**IN THE COURT OF THE STATE COMMISSIONER  
FOR THE SPECIALLY-ABLED PERSONS**

Memo No.- SCPD/RAJ/SJE/2024/19158-161

Subj- "That I have visited The Jaipur Junction Railway Station, Jaipur,  
Rajasthan on 28-10-2024 During this visit, came across many  
short-comings in facilities for specially abled persons"

### TICKET COUNTER

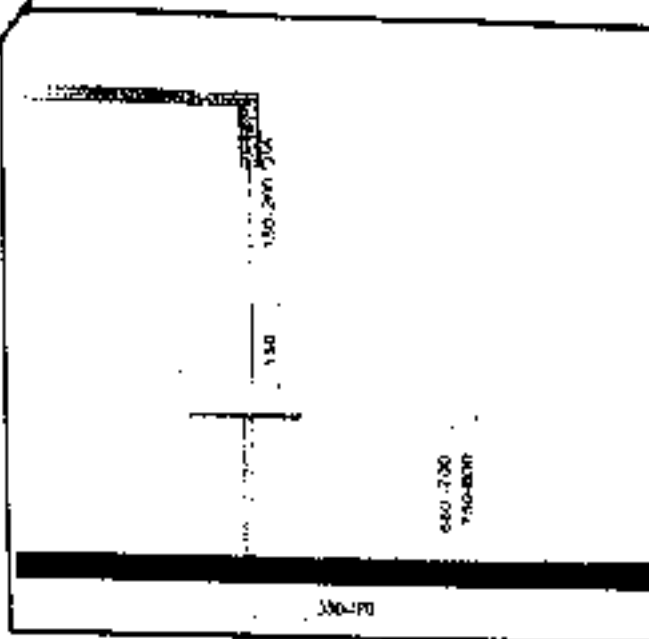
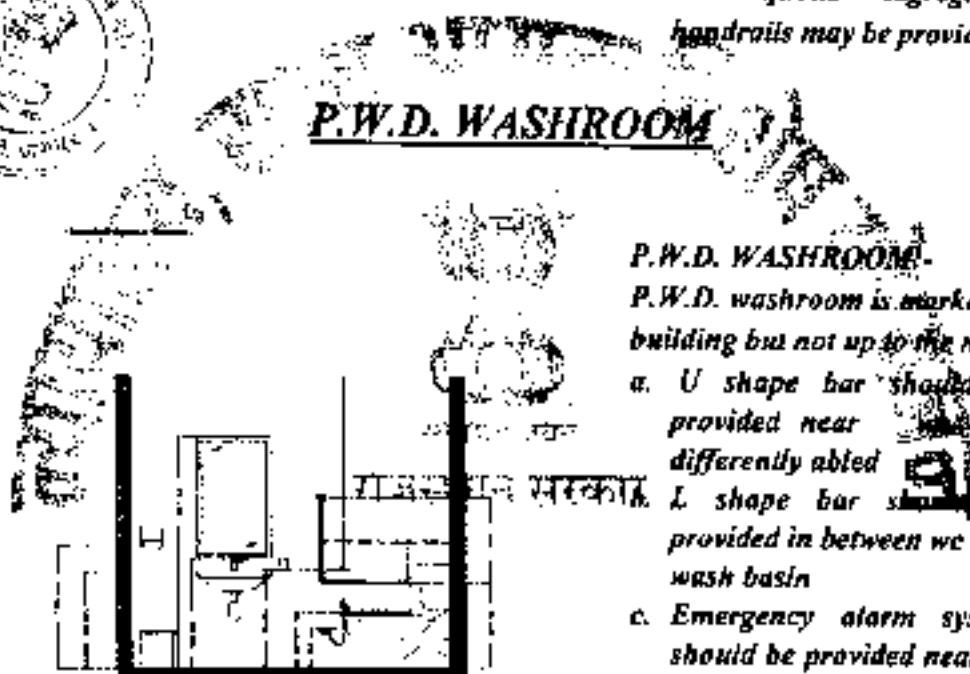
Accessible reception is available, but partially accessible.

1. Provision of low height ticket and enquiry counters

2. Priority shall be given to Divyangjans in queues at the ticket booking office. The queue segregating handrails may be provided.

## ACCESSIBLE DRINKING WATER

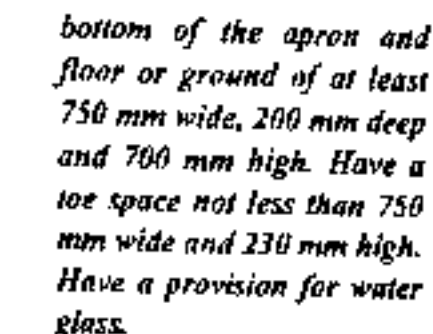
*Proper drinking water facility  
is not provided*

- J. Drinking water coolers or taps should: Have a clear floor space of at least 900 mm x 1200 mm, have a clear knee space between the*

2. Accessible drinking water fountains for wheelchair users may be placed at a height of 750 mm with above features. Refer Fig: 4.21
3. The drinking water counter may be projected upto 480mm from the edge of the wall surface.

4. Freestanding or built-in drinking water coolers or taps not having a knee space should have a clear floor space of at least 1200 mm wide x 900 mm in front of the unit.
5. All wall-mounted drinking water provision in an alcove is preferred, because it does not create a hazard for persons with visual impairments.
6. Tap should not be of lever nature.

### ACCESSIBLE LIFT

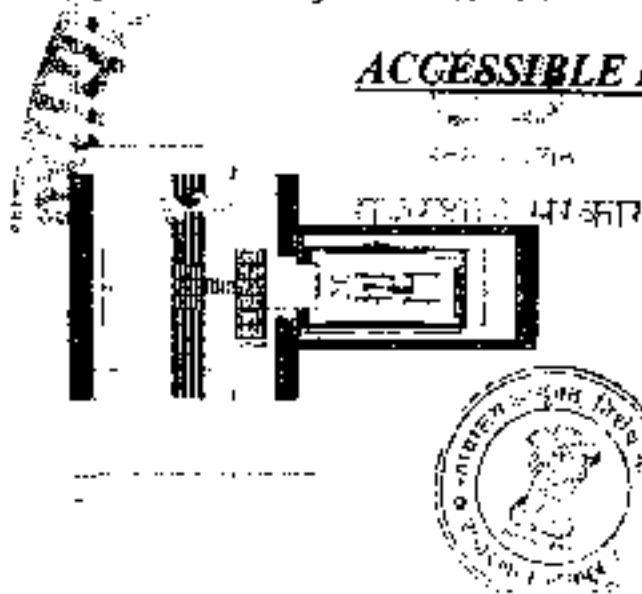
*Lift is provided but not accessible*

- The minimum size of the lift should be 1900 mm x 1900 mm for all new establishments, where the space is not available, the lift size shall be a minimum of 1500 mm x 1500 mm

- The lift door should have a clear opening of not less than 900 mm.
- Grab bars to be placed at a height of 800 mm to 900 mm from the floor level. Be fixed on both sides and at the rear of the lift.
- Where lifts are provided in a building they shall be accessible to and usable by Persons with Disabilities at all levels used by the general public or staff. Elevators should be marked with the symbol of accessibility and directional signs be provided to the lifts. Eg braille signage.
